20/00869/FULEIA 2-3 Finsbury Avenue, London, EC2M 2PF

Development Description: Notification from the City of London of application ref: 20/00869/FULEIA for the demolition of the existing buildings and construction of a new building arranged over three basement levels, ground and 37 upper floors to provide an office-led, mixed use development comprising commercial, business and service uses (Class E), flexible commercial, business and service uses /drinking establishment uses (Class E/Sui Generis); and learning and nonresidential institutions uses (Class F1); creation of a new pedestrian route through the site at ground floor level; hard and soft landscaping works; outdoor seating associated with ground level uses and other works incidental to the development. (The development would provide 85,009sq.m GEA of office floorspace (Class E); 4,397sq.m GEA of commercial, business and service uses (Class E); 1,097sq.m of flexible commercial, business and service uses /drinking establishment uses (Class E/Sui Generis); 2,239 sq.m GEA of learning and non-residential institutions uses (Class F1); and 16,058sq.m of ancillary plant, back of house and storage; total floorspace 108,800sq.m GEA;

DRAWINGS ILLUSTRATING THE GAP BETWEEN THE TOWERS

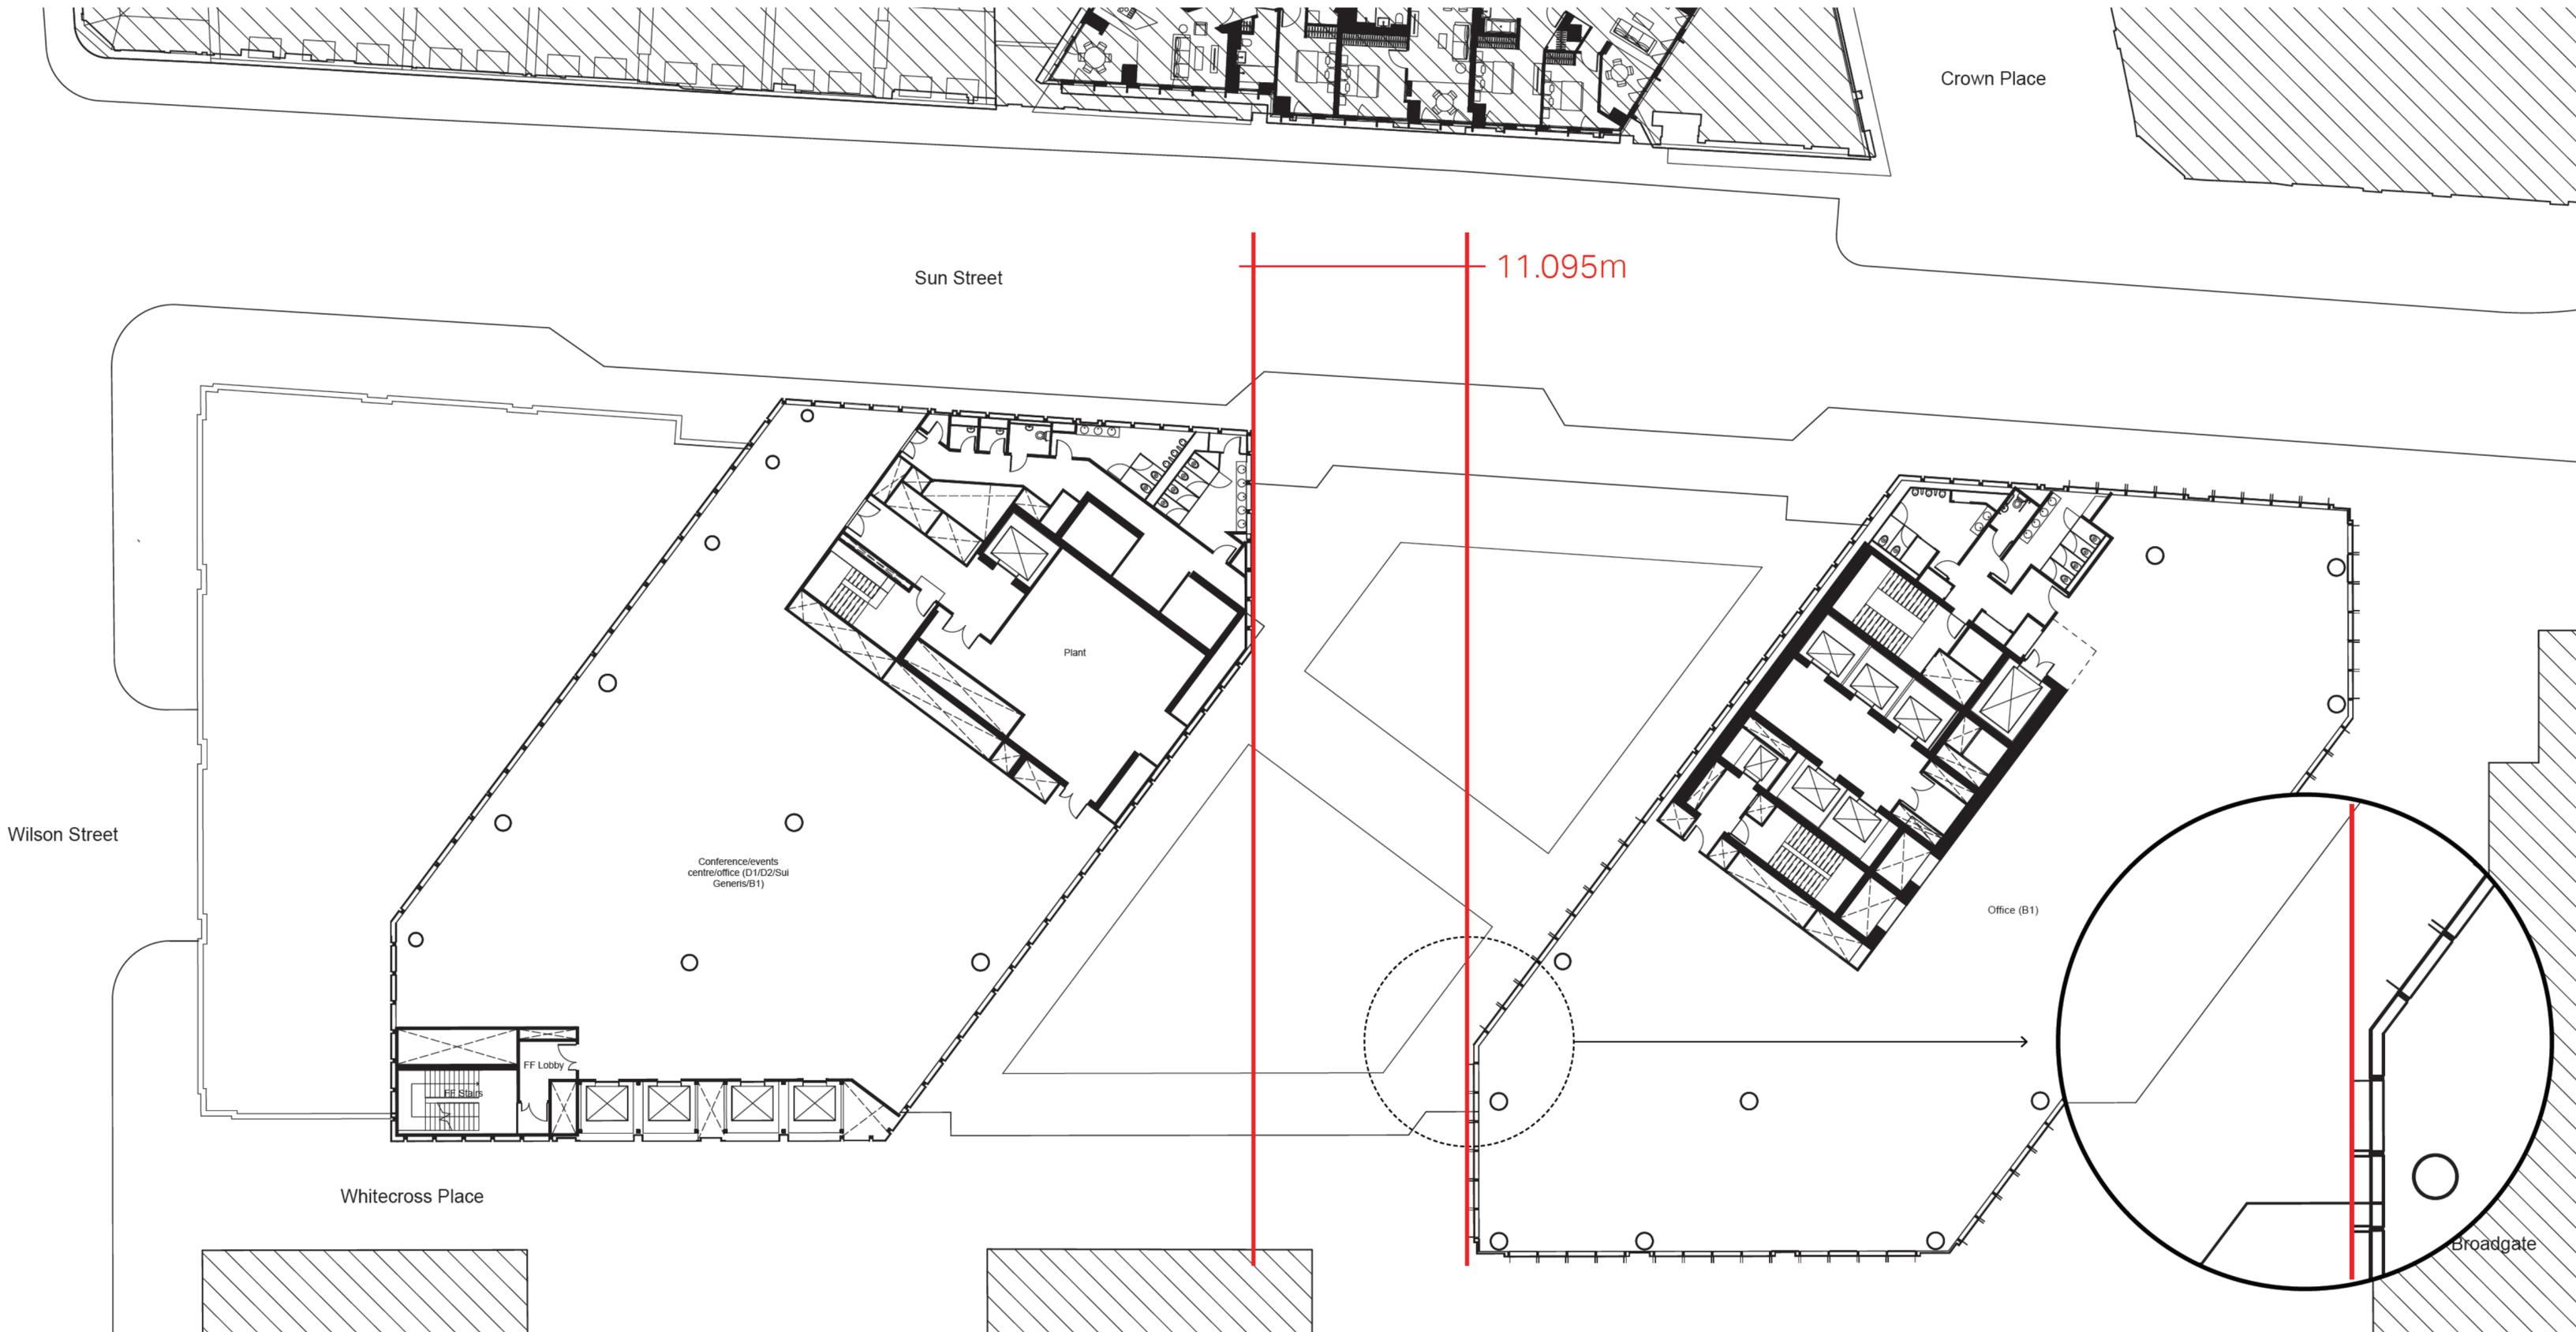
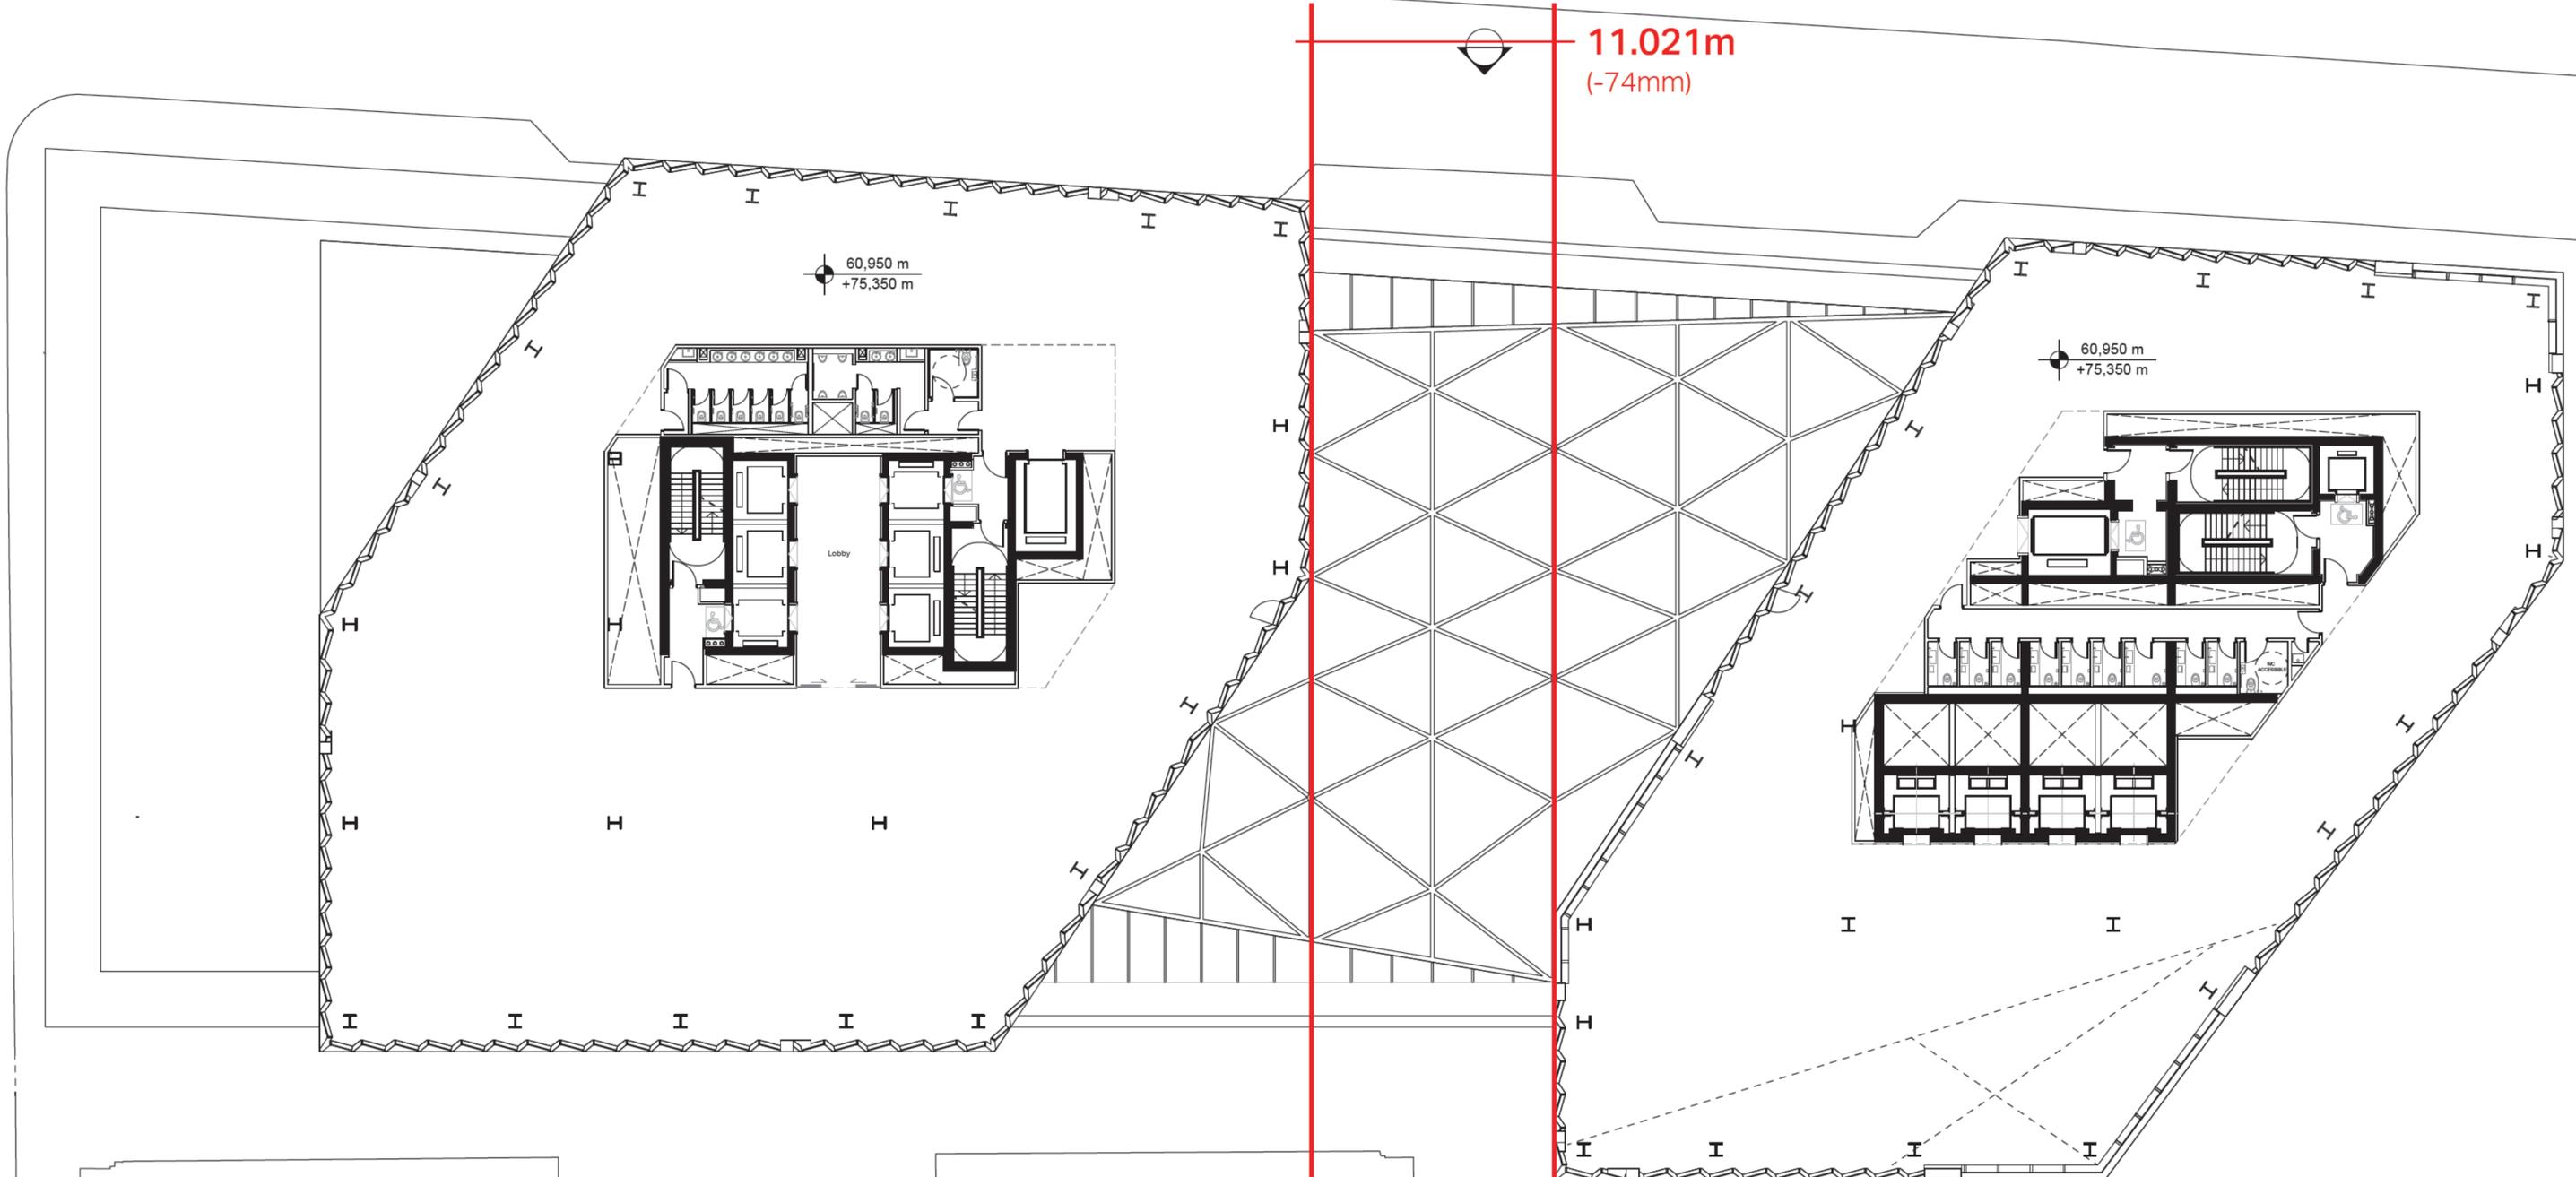
Alongside the daylight and sunlight impacts, our client is also concerned with the appearance of a decreased gap between the western and eastern towers (see Figure 3). Whilst we appreciate in parts the 'gap' between the towers is the same or similar to the 2016 Application, in other parts it appears from KPFs analysis that the gap between the towers does reduce. We are concerned that reducing the 'gap' will likely have a further implication on the outlook and sense of enclosure experienced by the residents looking south from the southern residential tower within the OCP scheme. This was a key point within the 2016 Application and the 'gap' between the towers should be retained to protect the amenity of residents.

The retention of a gap between the towers that is the same approximate width and location as that within the consented scheme formed part of the brief to 3XN when developing initial concepts for the redevelopment of the site. The drawings attached at Annex 2 provide an accurate comparison between the consented scheme and the proposed development. These drawings provide an accurate assessment of the gap because they have both been measured directly from digital models of the buildings. The AMTD letter does not explain how the images shown on page 4 of the letter were produced so it is not possible to verify their accuracy.
